Page 1-1 – The WSRP describes the 30% reduction of pumping rights. RBMB suggests adding context and history to the water rights adjustment– Decreed rights were raised too high in 1955 and not reevaluated from time to time as suggested in 1955.

City of Pasadena
April 27, 2021
Page 5

Anthony C. Zampello
Executive Officer
Raymond Basin Management Board

Subject: Raymond Basin Assessment

Figure 1 - Historic and Projected Pasadena Subarea Levels

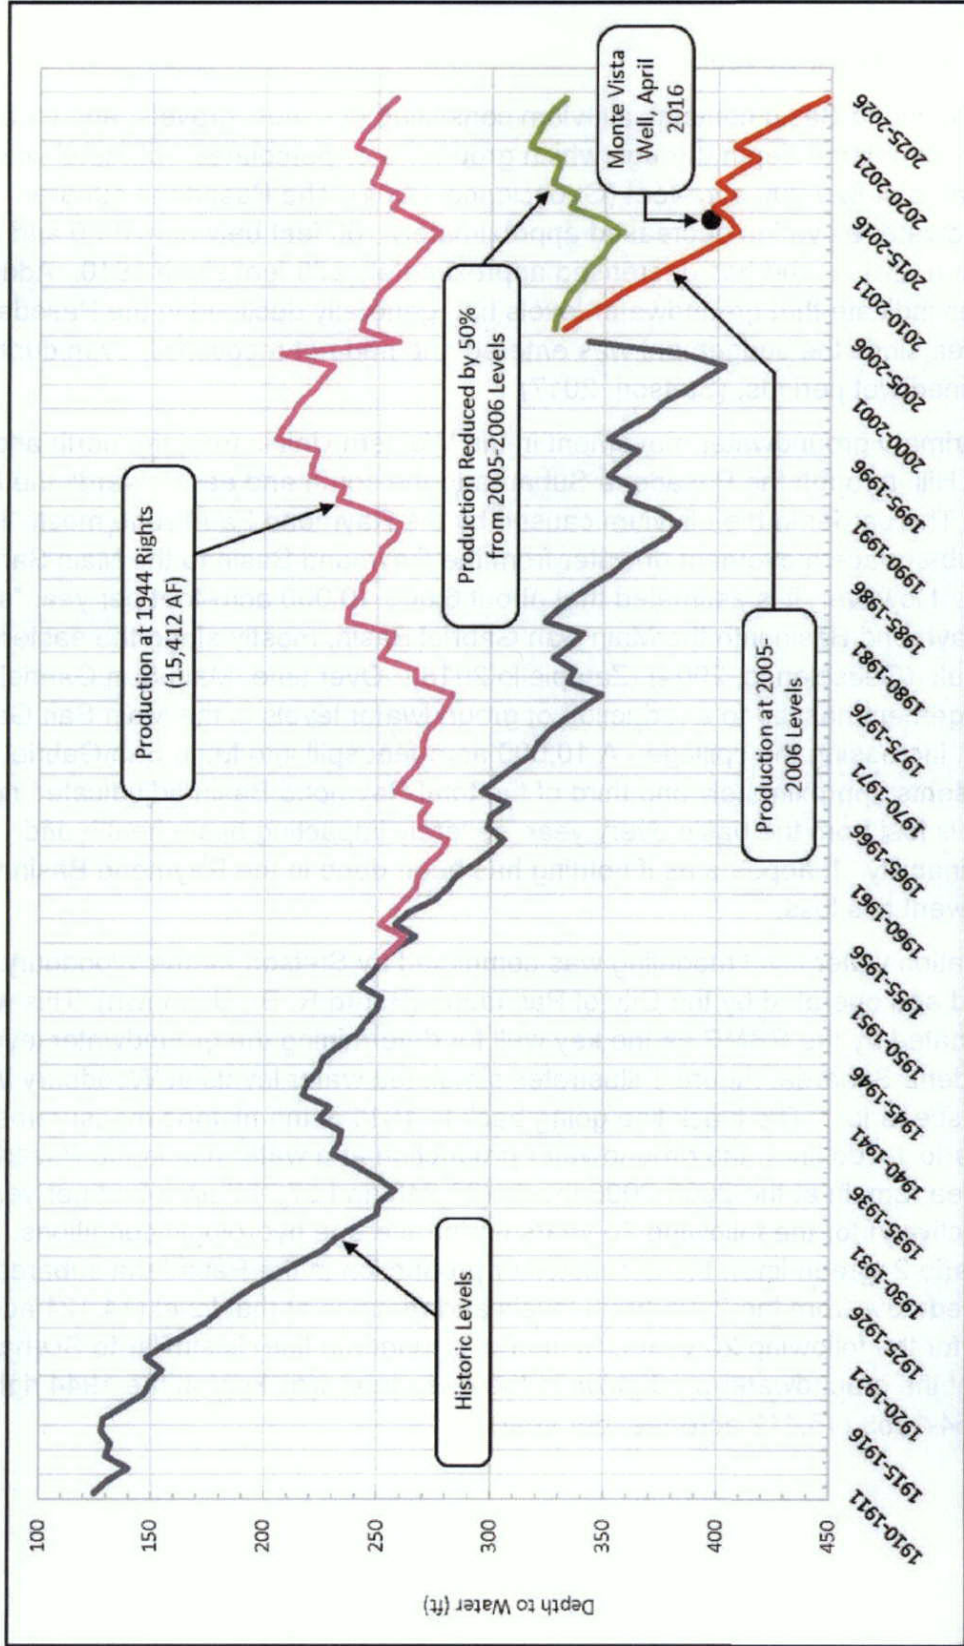
Page 2-17 – The WSRP includes “Historic Pasadena Area Groundwater Levels” and indicates source is from RBMB Draft Opportunities to Enhance Groundwater Levels in Pasadena Subarea. RBMB does not recognize this graph. Please indicate where the graph was obtained and which well(s) the water levels represent and provide a location map of why this is a good representation of the Pasadena Subarea.

Information available in 2009 when the resolution was adopted to curtail pumping by 30% clearly showed that the curtailment would not obtain stated goals (i.e., 50 feet increase in ground water levels). Modeling information shown in Figure 1 indicated that
